Genesis Solar Energy Project - Docket Number 09-AFC-8

ADDENDA TO GENESIS SOLAR ENERGY PROJECT

DATA REQUEST RESPONSES TO SET 1A, DECEMBER 15, 2009:

DATA REQUESTS 64, 65, AND 120

FIGURE BIO-DR 64A 1
HONEY MESQUITE COMMUNITIES
ALONG NORTHWESTERN AND
SOUTHWESTERN PALEN DRY LAKE

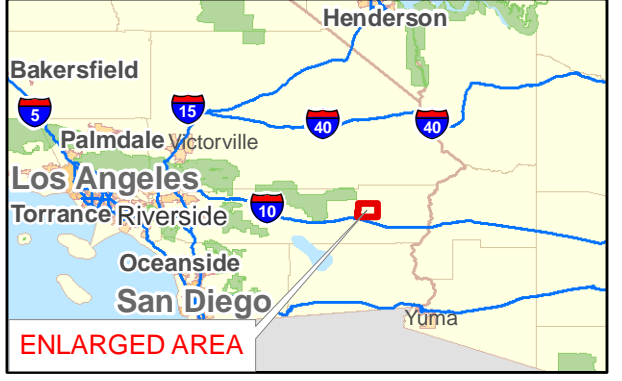
Bordering Palen Dry Lake are two species that are commonly associated with groundwater: honey mesquite (*Prosopis glandulosa*) and tamarisk (*Tamarix* sp.). Two honey mesquite communities are found along northwestern Palen Lake and west of the dune field at the southwestern end of Palen Lake (Figure BIO-DR 64A 1). The total area is 2247 ha. There are two, individual clones at the southern tip of Palen Lake and a single, clone of probable mesquite (based on a comparison on aerial photographs to
